# SITE DEVELOPMENT PLAN

## for BUNTING MULTIFAMILY FILING NO. 1, EL PASO COUNTY, COLORADO

BUNTING MULTIFAMILY  
SITE DEVELOPMENT PLAN

COVER SHEET

DP-1 MVE PROJECT 61072  
-DEV-CS MVE DRAWING

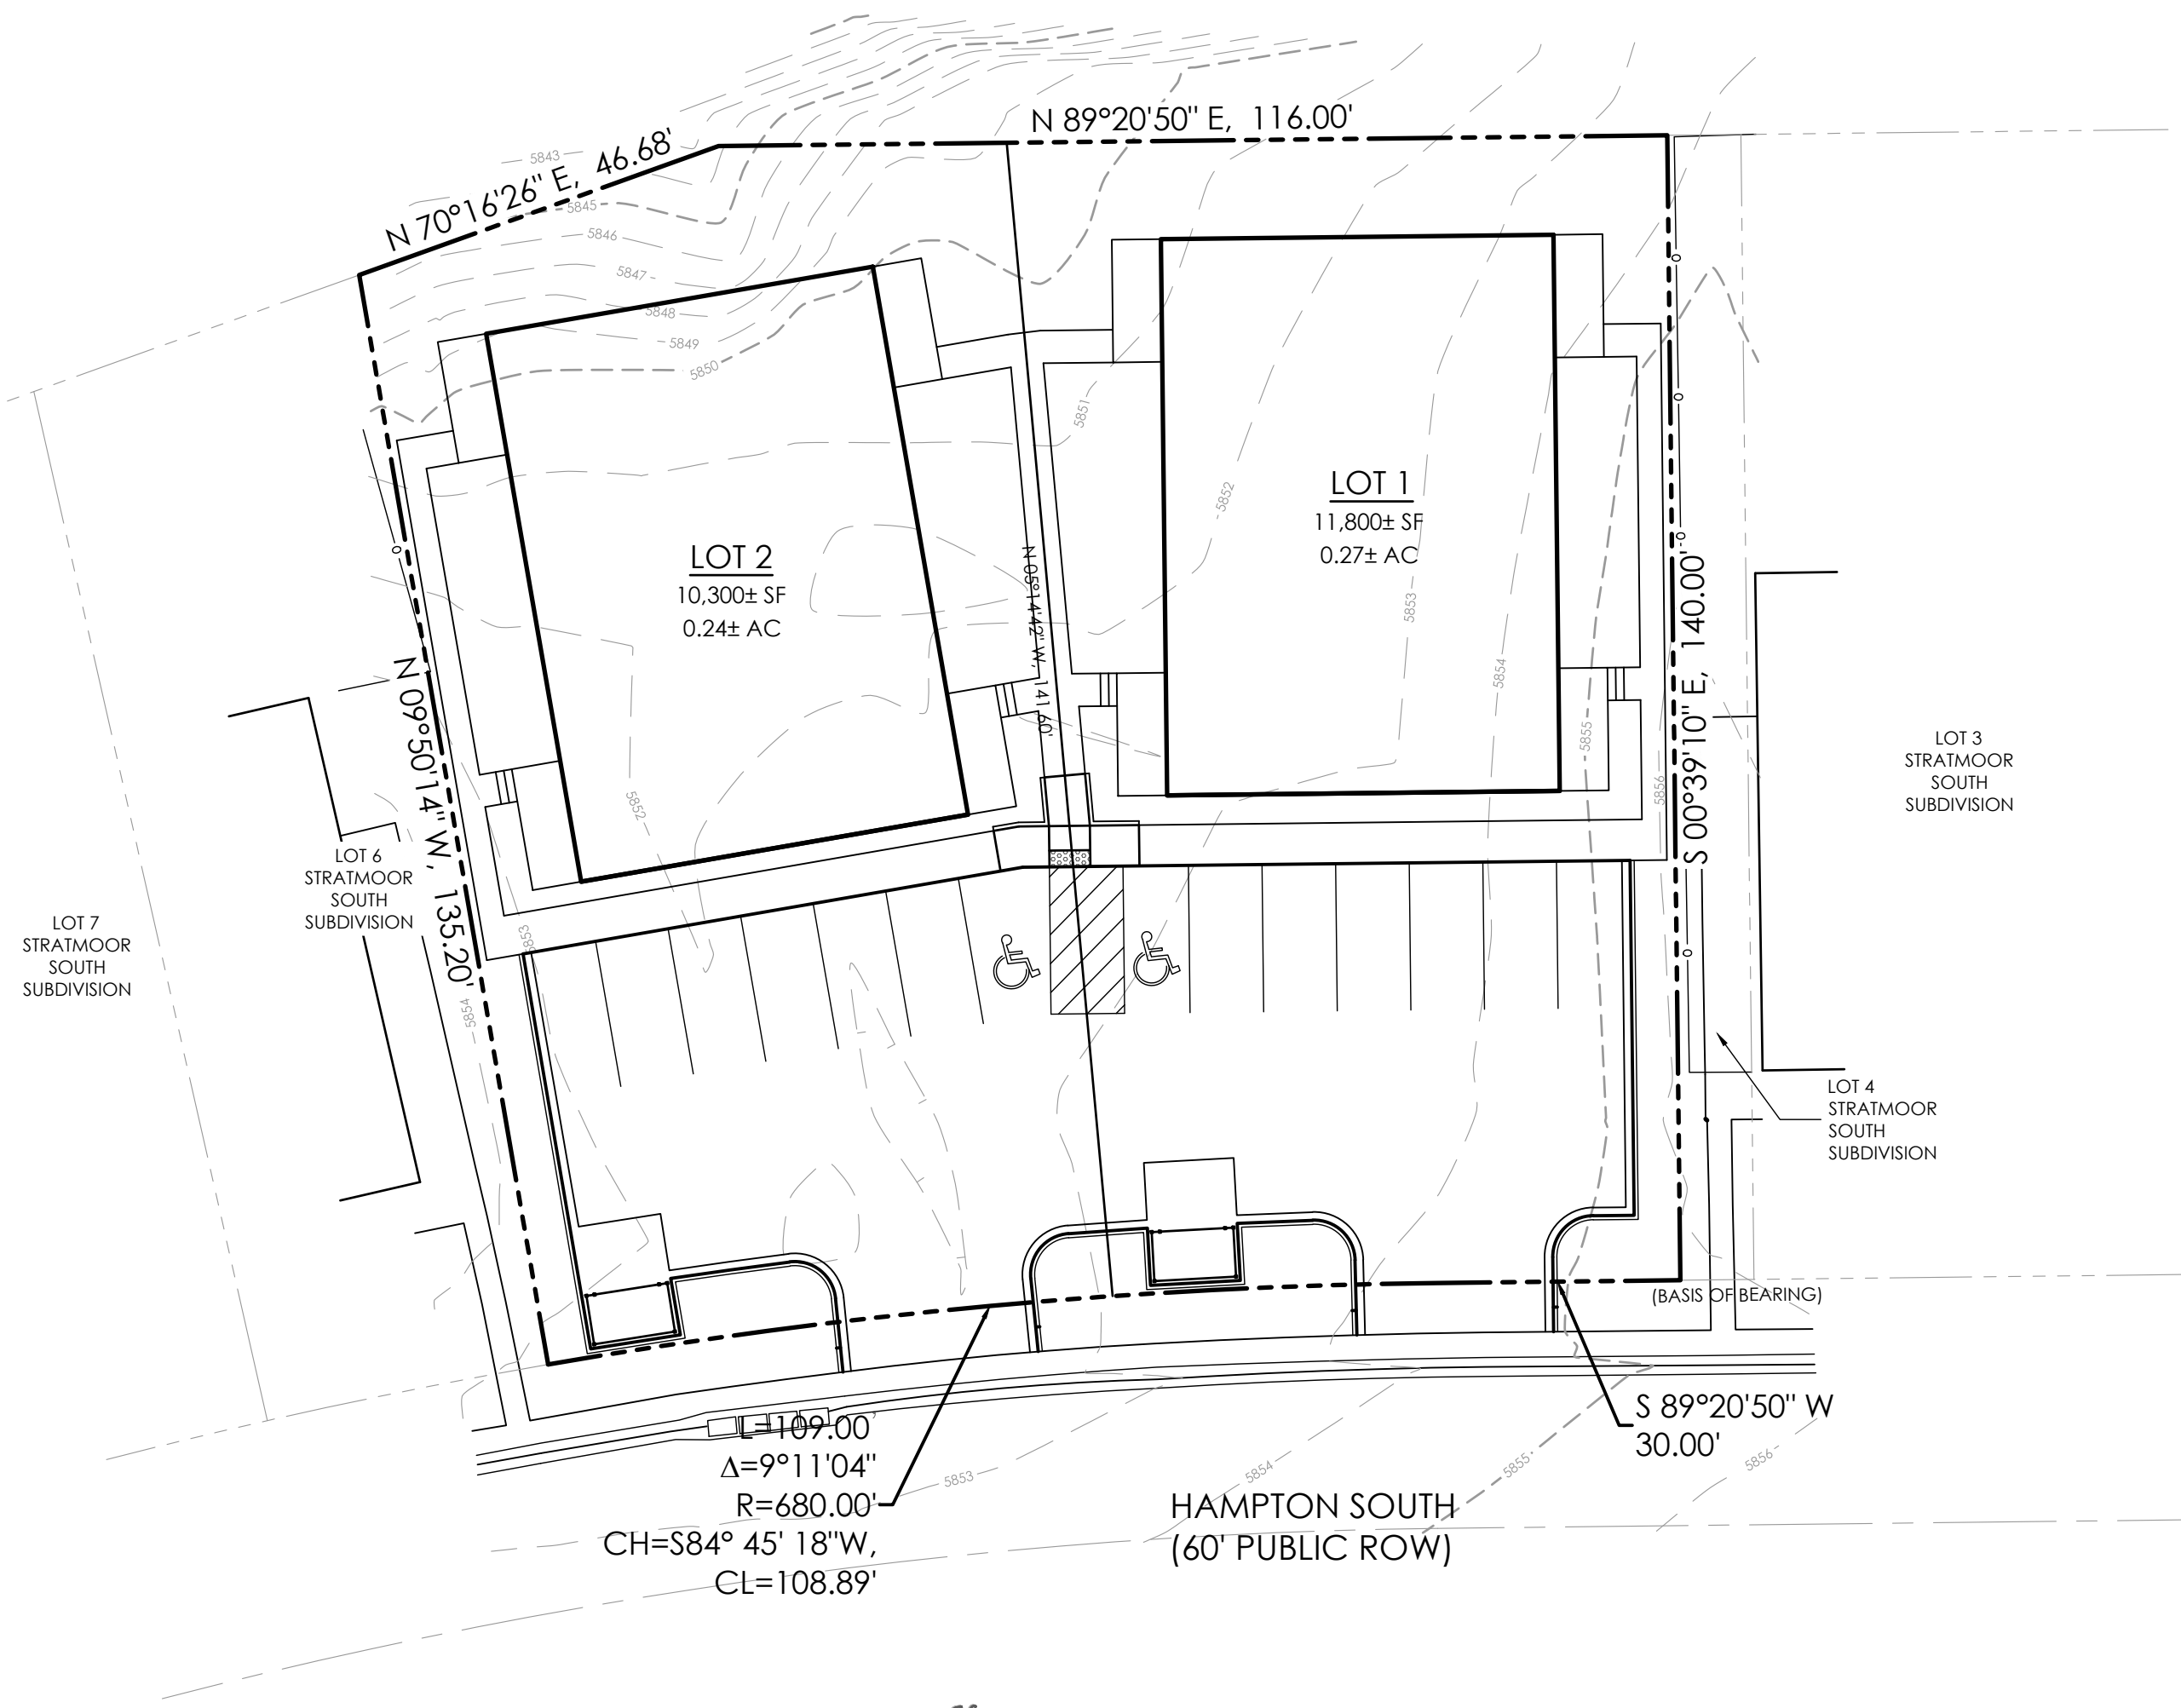
Should the request for administrative relief be denied, the plans will need to be revised to meet the setback and parking requirement.

Add a grading plan for the proposed grading.

DP-2 MVE PROJECT 61072  
MVE DRAWING -DEV-SP

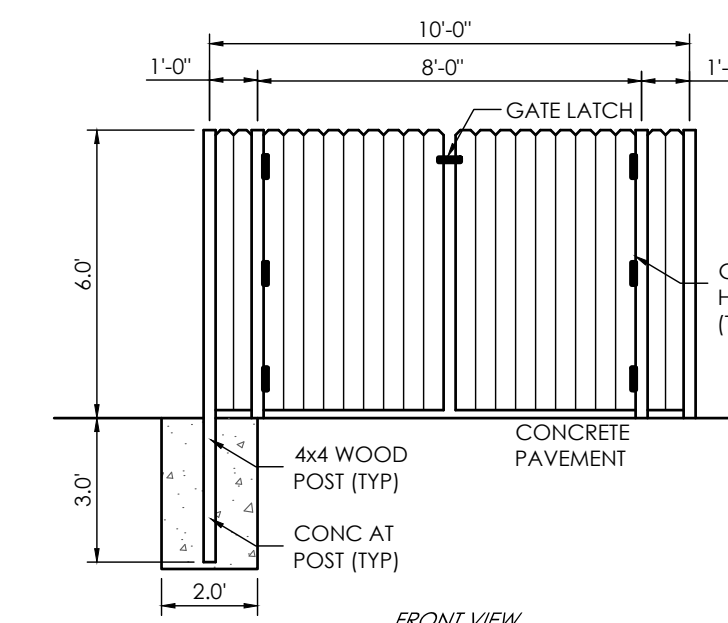
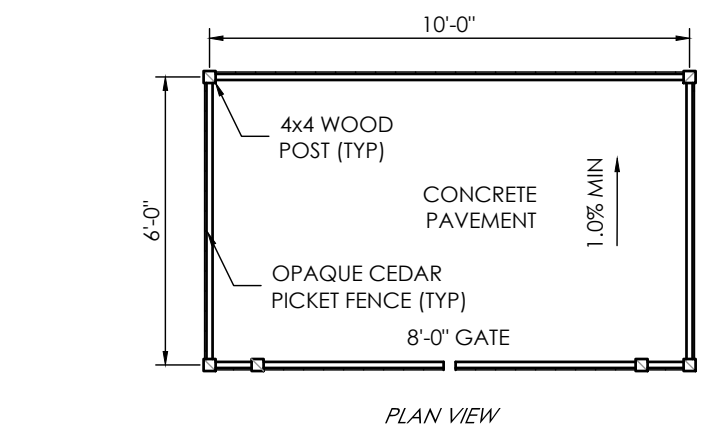
Show proposed grading contours on a separate grading plan.

While an ESQCP is not required, the applicant must obtain a BESQCP prior to construction.

These porches may not be covered, otherwise they do not meet the setback requirements.

This appears to be a fill area. Will there be a retaining wall at the back of the lot. On the grading plan identify the 100yr WSEL.

Label Fisher's Canyon and show the 100yr floodplain boundary

Identify the Finished Floor Elevation for both buildings on the grading plan

Will someone be able to back out of this space with the curb and gutter?

Show the incoming and outgoing pipe for the inlet. According to the County GIS (attached), the stormline goes through Lot 2 and outfalls.

Applicant must field verify the actual storm drain location. The plat must include an easement along the stormdrain line.

Include the manhole in the legend. Show the pipe layout. This appeared to be sanitary sewer with an incoming line from the northwest. An easement may need to be placed along the line if it's a service line for Lot 6 in case it needs to be repaired/replaced.
